# "SIMPLE SOLUTIONS FOR '98"

## INTRODUCTION

***AUTOMATIC TRANSMISSION SERVICE GROUP***  
9200 S. DADELAND BLVD.  
SUITE 720  
MIAMI, FL 33156  
(305) 670-4161

Figure 1

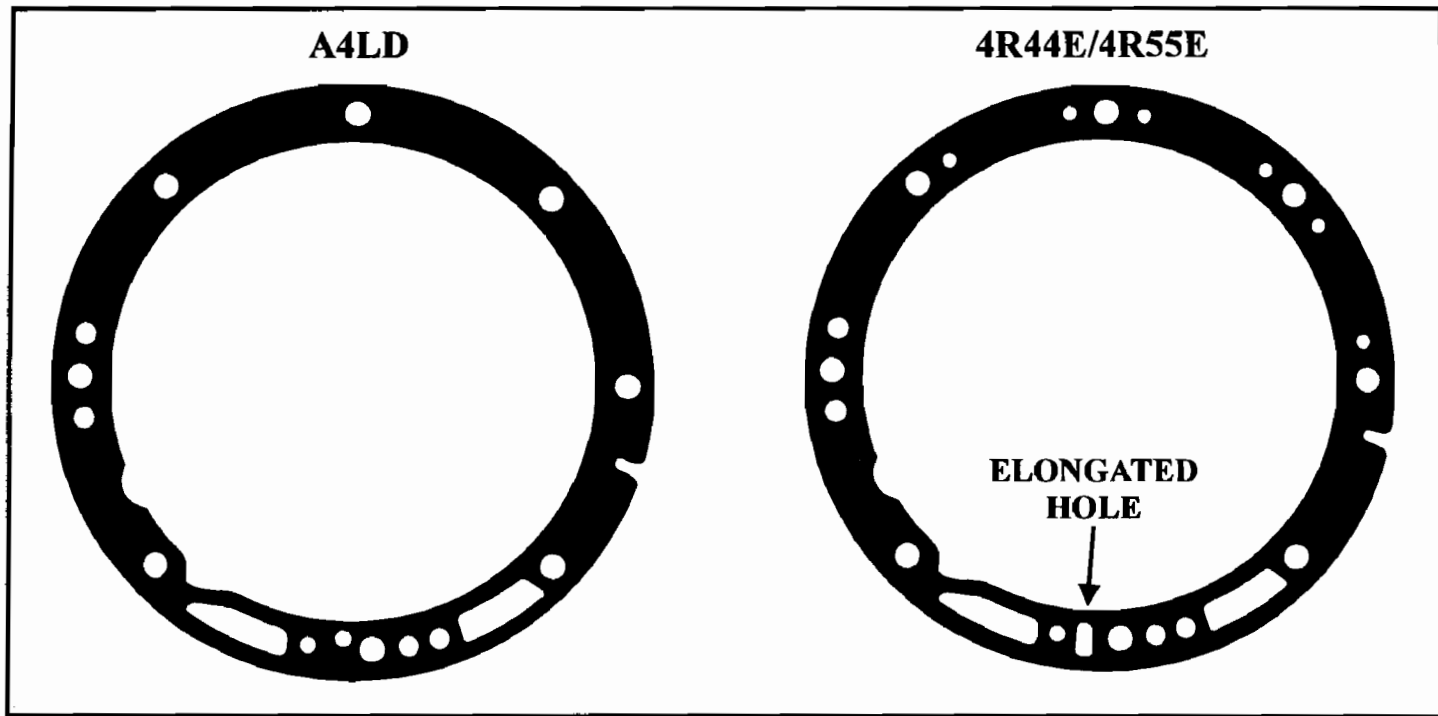
- (1) **PUMP GASKET** - An elongated hole was added to the 4R44E/4R55E pump gasket to accommodate changes in the related parts, for increased rear case lubrication. Refer to Figure 1.

Figure 2

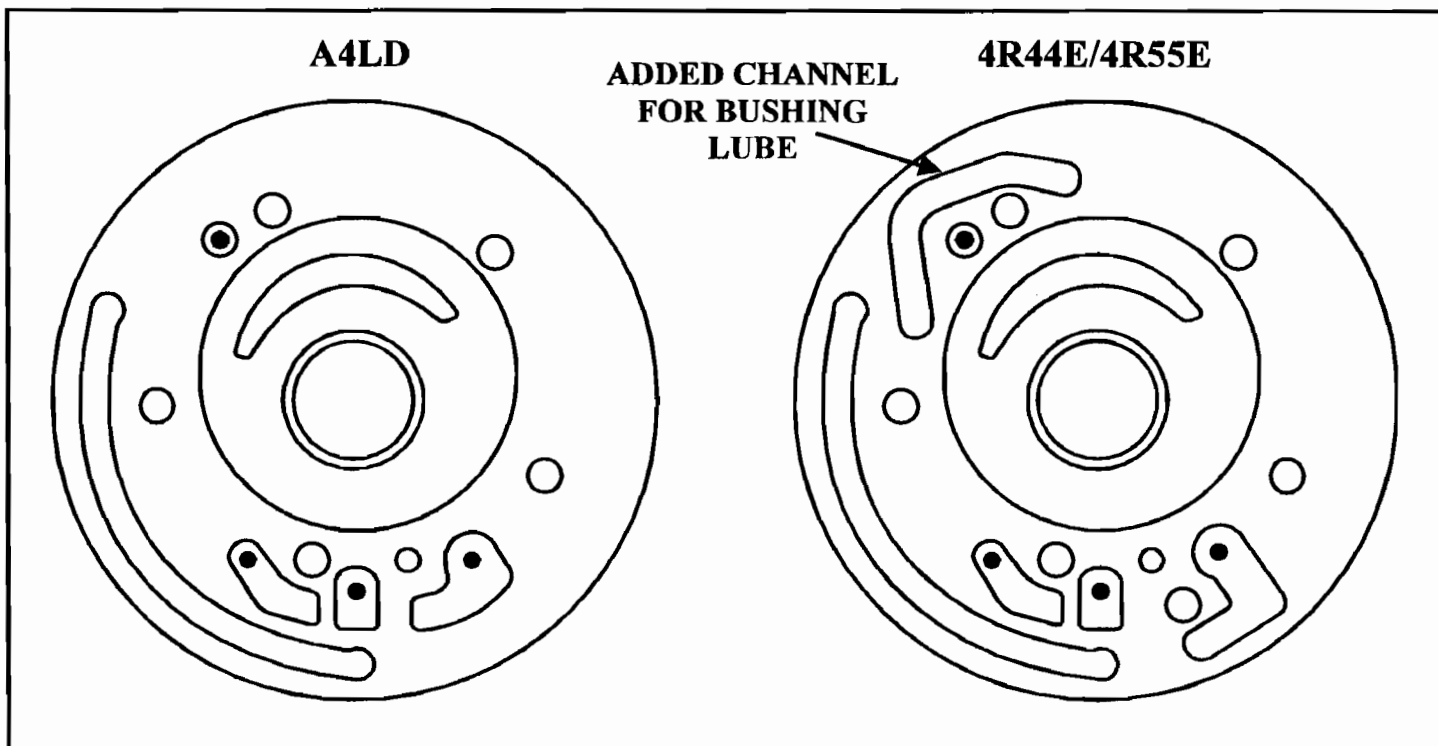
- (2) **PUMP BODY** - Added channel in the 4R44E/4R55E pump body for improved converter hub bushing lubrication, and a new bolt hole to accommodate an added bolt for increased clamping. Refer to Figure 2.

Figure 3

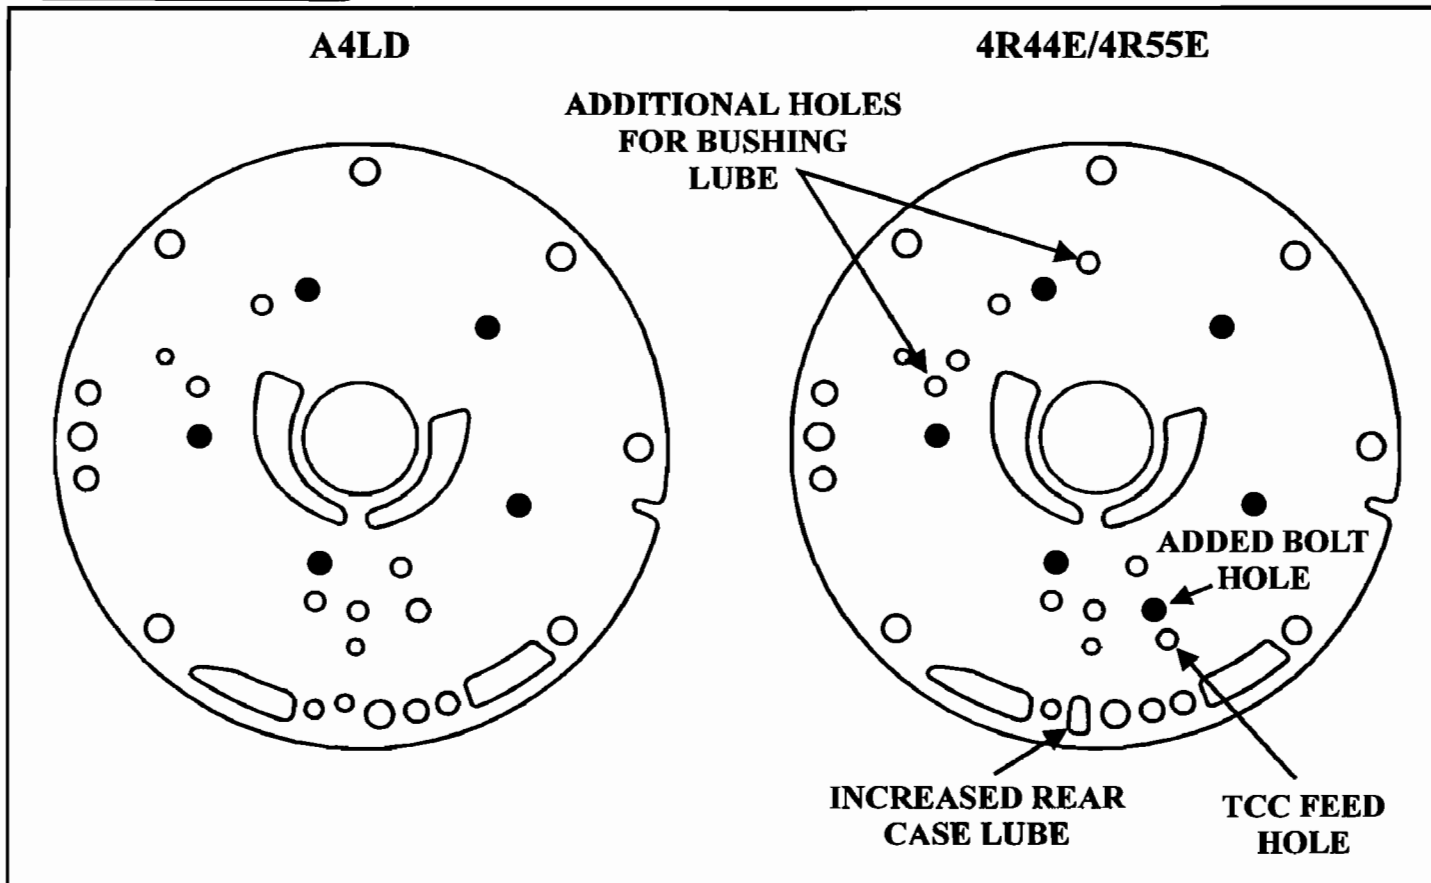
- (3) **PUMP PLATE** - The 4R44E/4R55E pump plate has two additional holes to accommodate the added channel in the pump body, an added bolt hole for the added bolt, an elongated lube hole, and the TCC feed passage was relocated. Refer to Figure 3.

Figure 4

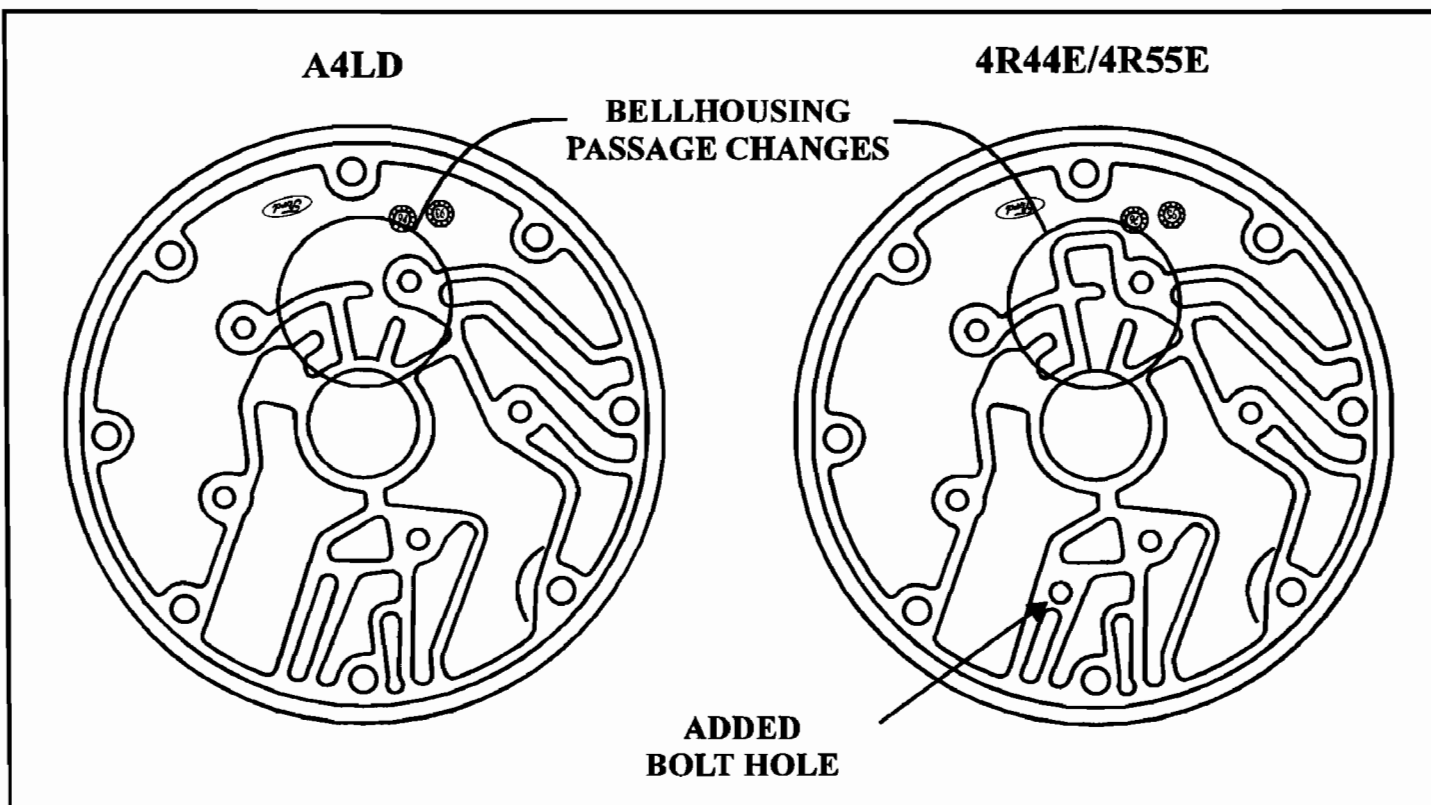
- (4) **BELLHOUSING** - The 4R44E/4R55E bellhousing has an added passage to accommodate the pump body changes for increased lubrication to the converter hub bushing, as shown in Figure 4.

Figure 5

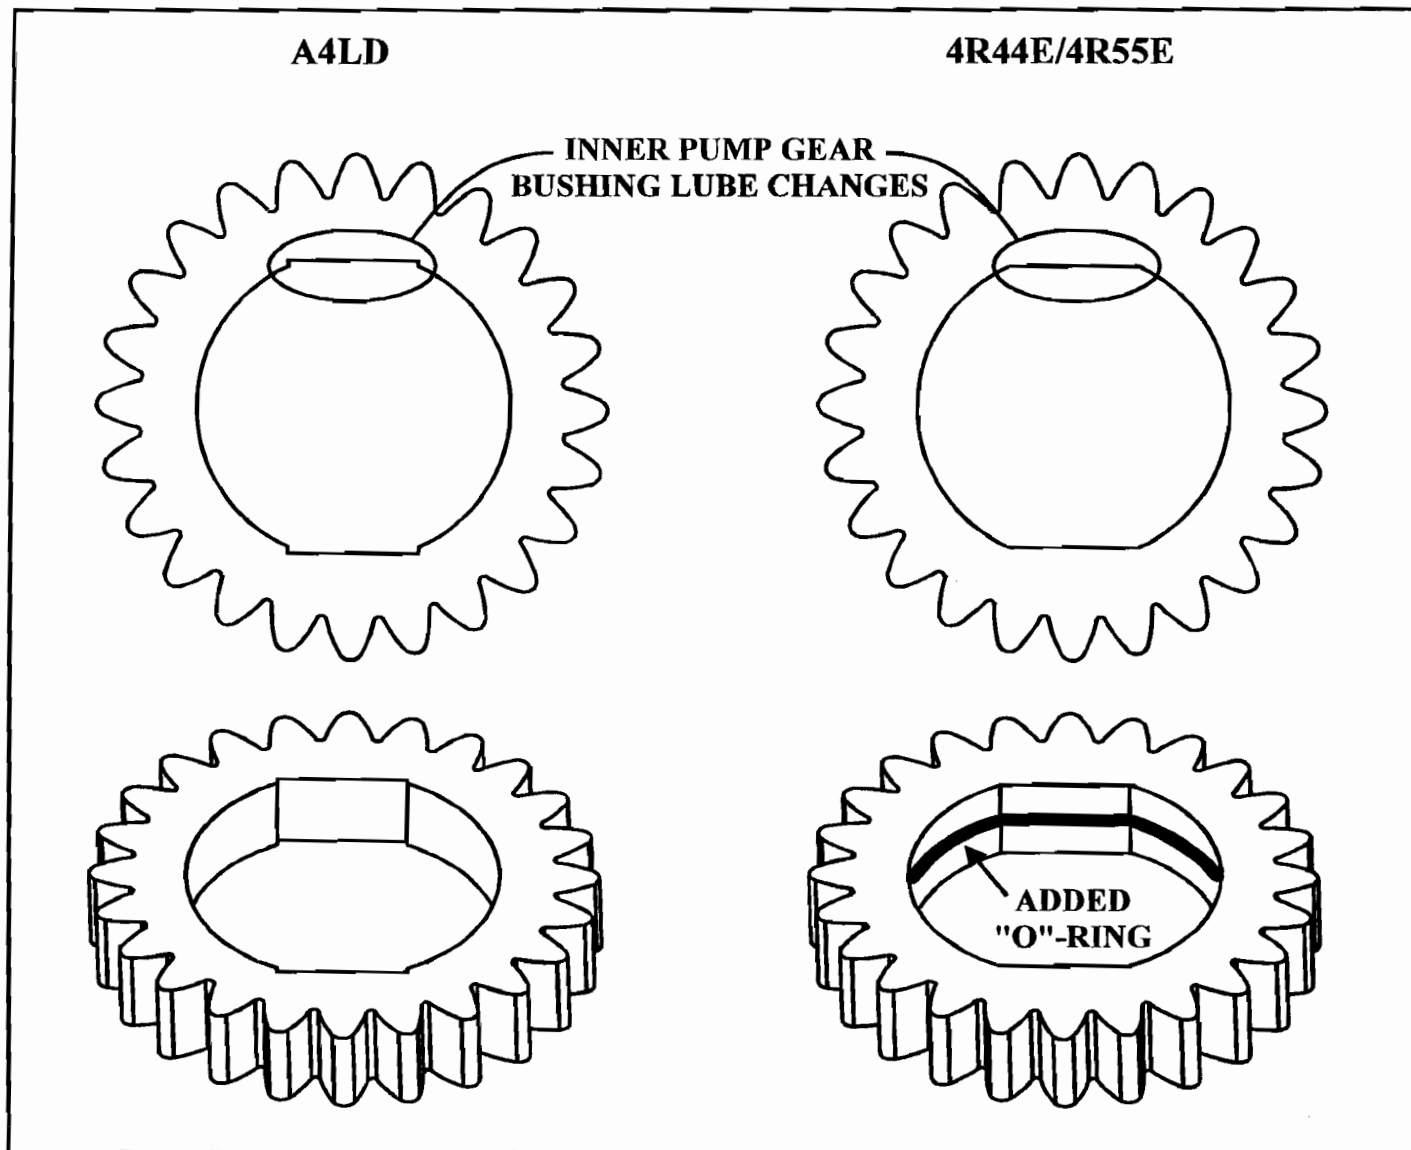
- (5) **INNER PUMP GEAR** - The 4R44E/4R55E inner pump gear has an easily missed change to the inside diameter and an "O" ring added in a new groove on the inside diameter to accommodate the re-routing of converter hub bushing lubrication, as shown in Figure 5.

Figure 1

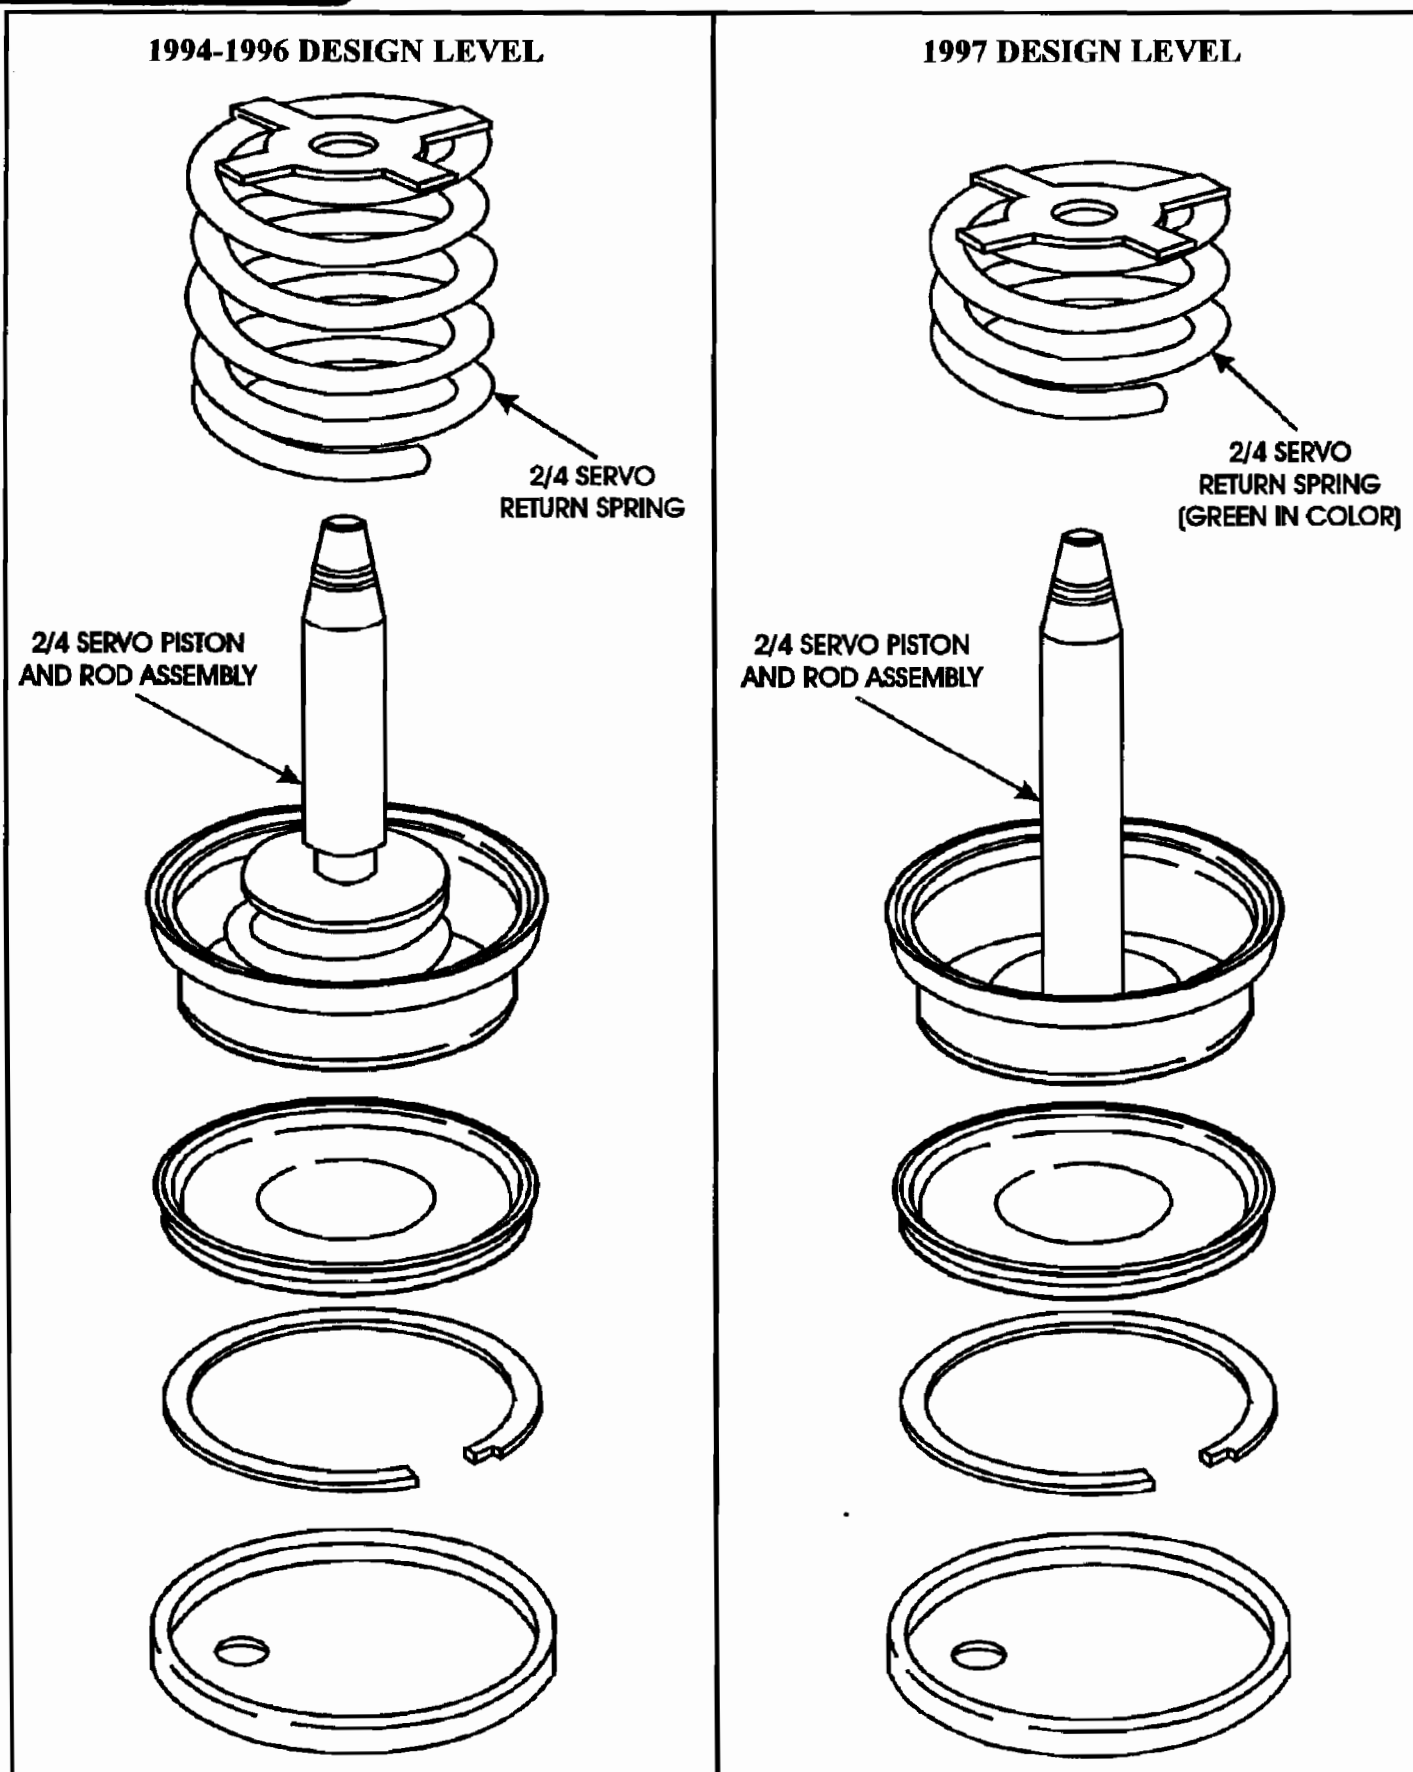
**CHANGE:** Beginning at the start of production for 1997 Probe models equipped with the CD4E transaxle, will contain a revised *one piece* intermediate/overdrive servo piston and rod assembly, and a new design servo piston return spring assembly, which is now green in color (See Figure 1).

- (1) SERVO PISTON AND ROD ASSEMBLY - 1997 Probe models are now a one piece design as shown in Figure 1.
- (2) SERVO RETURN SPRING ASSEMBLY - Now has a revised return spring (Shorter) and is green in color for identification, as shown in Figure 1.

Figure 1

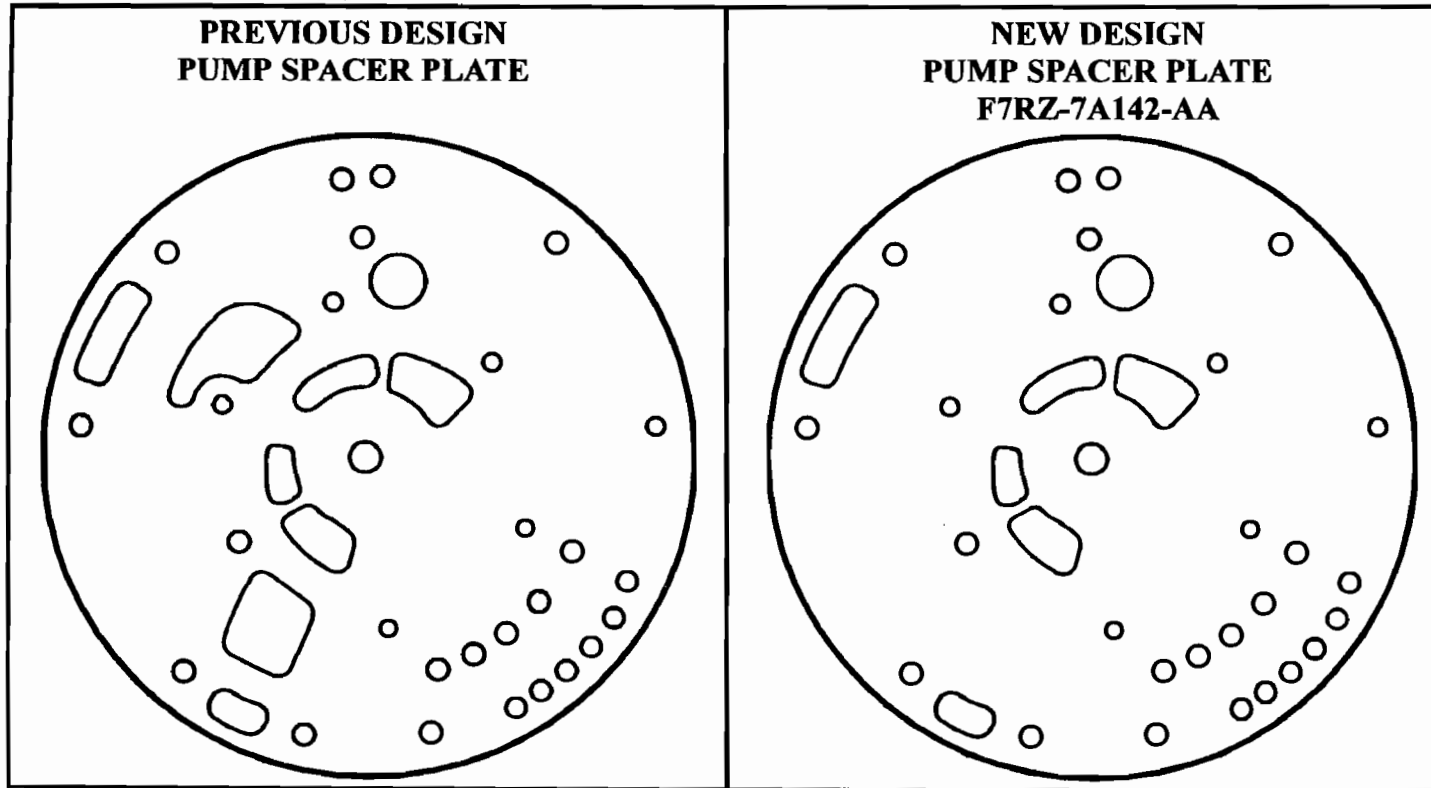
**PUMP SPACER PLATE** - New design level has two less holes, as shown in Figure 1.

Figure 2

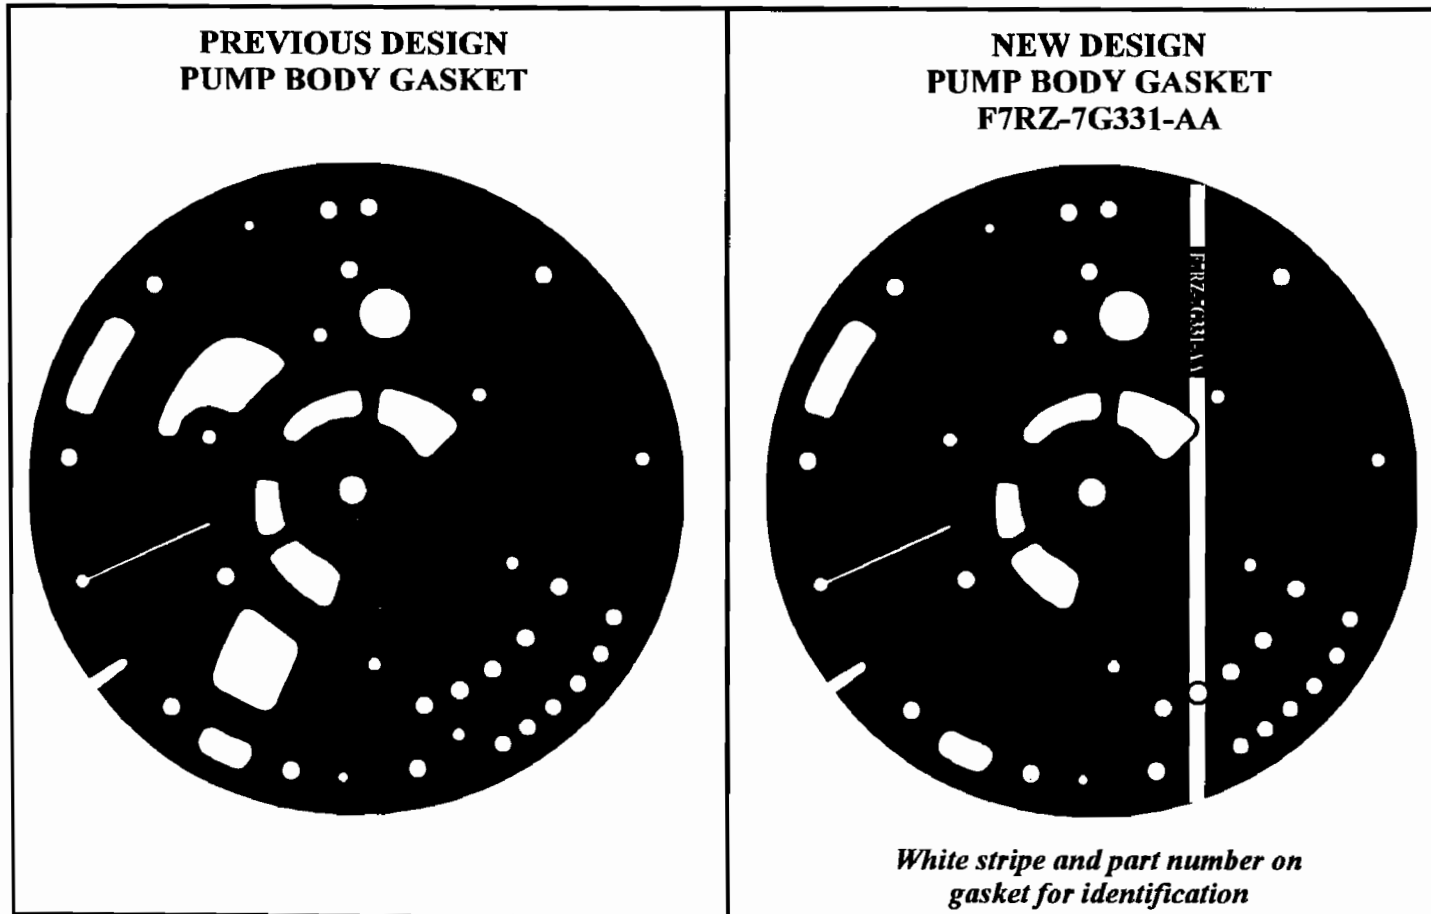
**PUMP BODY GASKET** - New design level has two less holes and is identified with a White stripe and part number on the gasket, as shown in Figure 2.
